**DOCKET NO: A-98-49  
II-B1-17**

**TECNICAL SUPPORT DOCUMENT FOR SECTION 194.27:  
SANTOS COMPUTER CODE  
IN WIPP PERFORMANCE ASSESSMENT**

**U. S. ENVIRONMENTAL PROTECTION AGENCY  
Office of Radiation and Indoor Air  
Center for the Waste Isolation Pilot Plant  
1310 L St., NW  
Washington, DC 20005**

**March 2005**

Figure 5. Detail of the deformed disposal room with waste for  $f=0$ :  
at 300 years (Figure 5a) and at 10,000 years (Figure 5b)  
(from Stone 1997a, Figures 9 and 10).

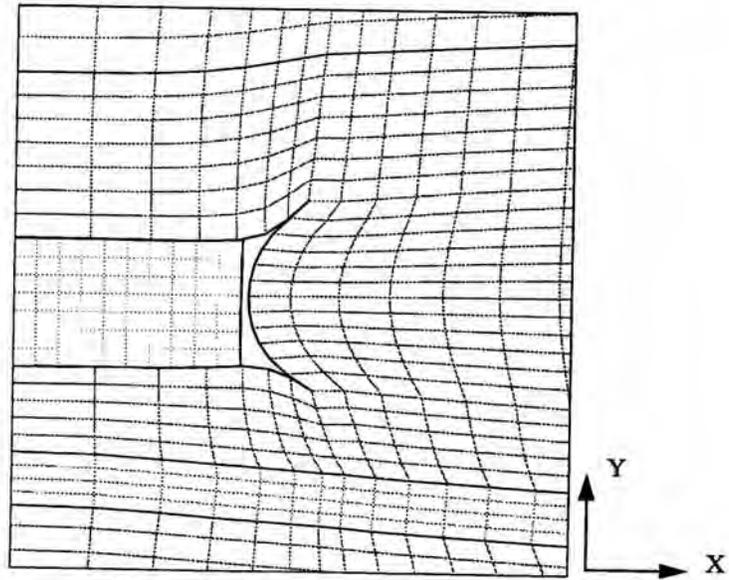
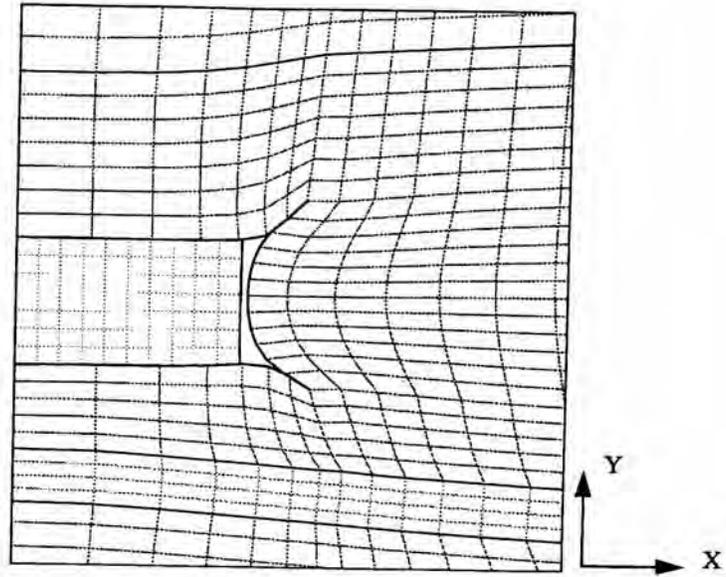
Figures 5a and 5b show the SANTOS-predicted, deformed waste room after 300 and 10,000 years for the case of no gas generation ( $f = 0$ ; Stone 1997a, Figures 9 and 10). As shown in the illustrations, the free space around the waste closes relatively quickly. The waste is essentially fully contacted within 300 years and undergoes relatively little subsequent volume reduction. Figures 6a and 6b show the SANTOS-predicted, deformed waste room after 300 and 10,000 years for gas production at half the reference case rate ( $f = 0.5$ ; Stone 1997a, Figures 11 and 12). Here the gas pressure becomes sufficiently high to allow essentially no further waste volume reduction after 300 years, and to reduce horizontal wall deformation to the point that no significant horizontal back pressure is provided by the waste for 10,000 years. This suggests that waste porosities can remain high and stresses on the waste can remain low when gas is produced in the repository.

EPA's principal accuracy issue with SANTOS is the relatively low mean stress exerted on the waste when no gas is generated, even after 10,000 years when halite creep should have caused the stress to more closely approach a lithostatic state. This low stress has resulted in higher porosities for the waste than would be expected. Several factors, discussed below, are believed to have caused this condition.

Figure 7. Pressure histories for various values of the gas generation parameter  $f$  (from DOE 2004, Appendix PA, Attachment PORSURF, Figure PORSURF-3).

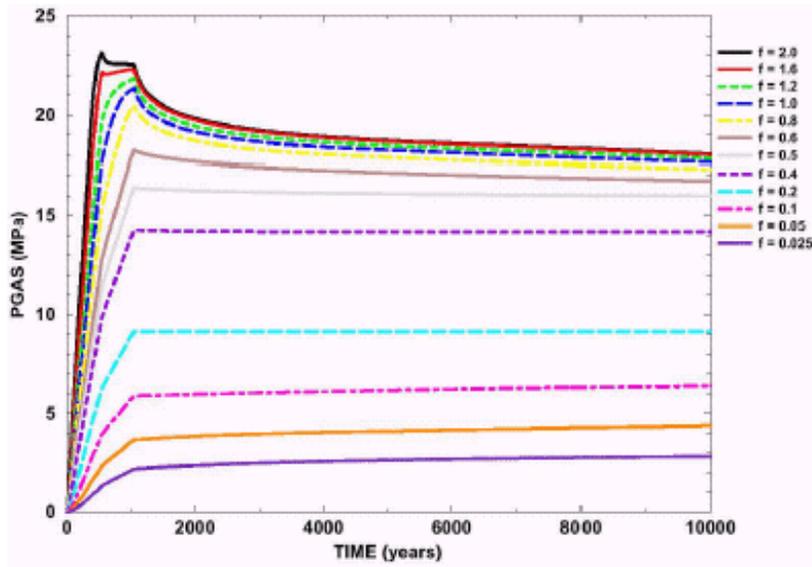
The foregoing conclusion is supported by the results on Figures 7 and 8. For purposes of generating the porosity surface, gas production in SANTOS is assumed to cease after 1,050 years (Stone 1997a, p. 4). Figures 7 and 8 show that for  $f = 0.5$ , after about 1,000 years the waste room gas pressure remains relatively constant at about 16 MPa and the porosity remains approximately constant at about 0.6. This gas pressure is more than sufficient to support the lithostatic pressure of about 15 MPa (F.D. Hansen et al 2003, Section 4.5). Of greater interest is the predicted porosity, shown in Figure 8, of about 0.235 after 10,000 years with no gas production ( $f = 0$ ). Considering the aforementioned initial waste porosity of 0.681, a reduction to 0.235 represents a volume strain of about 0.87. From Figure 1, this strain is equivalent to an average applied pressure of about 4 MPa, which is less than the lithostatic equilibrium pressure of about 15 MPa. This indicates that average stresses on the waste are predicted to remain well below lithostatic after 10,000 years, even with no gas pressure in the room. It is also noted that for the higher gas generation rates, generally for  $f > 0.5$ , the porosity history curves in Figure 8 show an increase in waste room porosity between about 500 and 1,000 years corresponding to room dilation.

Figure 9. WIPP convergence plots for E790 Drift-S2350, Room 3, Panel 2  
 (from TEA 2005; *SANTOS and Porosity Surfaces*, meeting handout by Bill Thompson, Golder Associates)

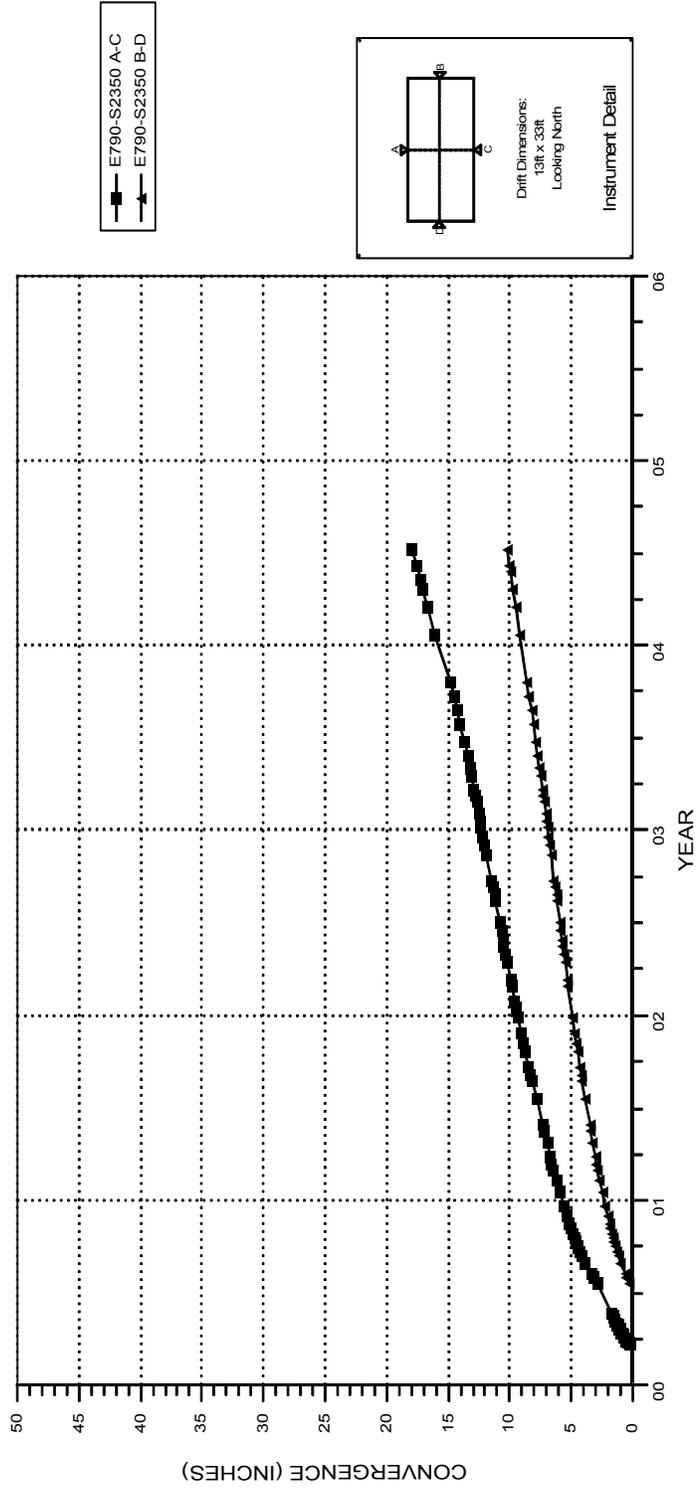
The foregoing considerations suggest that horizontal wall movement into the room would be less rapid than vertical roof and floor movement, even at early times. This expectation has been confirmed by convergence measurements in test drifts at WIPP, as illustrated by Figures 9 and 10 (EPA 2005, *SANTOS and Porosity Surfaces*, meeting handout by Bill Thompson, Golder Associates). The greater span of the roof and floor and the compounding effects of model element contact in the corners of the room provide an adequate qualitative explanation for the SANTOS model prediction of a lower horizontal stress in the walls, however the true magnitude of that stress and the accuracy of the related long-term, secondary halite creep rate after 10,000 years remain uncertain. Although the WIPP field measurements confirm the predicted short-term creep behavior of the halite, they do not address the accuracy of the very slow, long-term rate of return to a lithostatic stress state predicted by SANTOS. The conceptual model of a fairly rapid rate of return to lithostatic equilibrium conditions appears to have been based on recent and historic observations of room closure and halite encapsulation occurring within time frames of tens to hundreds of years and the assumption that the observed closure is accompanied by an equally rapid return to equilibrium stress conditions. However, the room closure observations have not been accompanied by in situ stress measurements and the rate of stress buildup accompanying room closure is therefore uncertain.
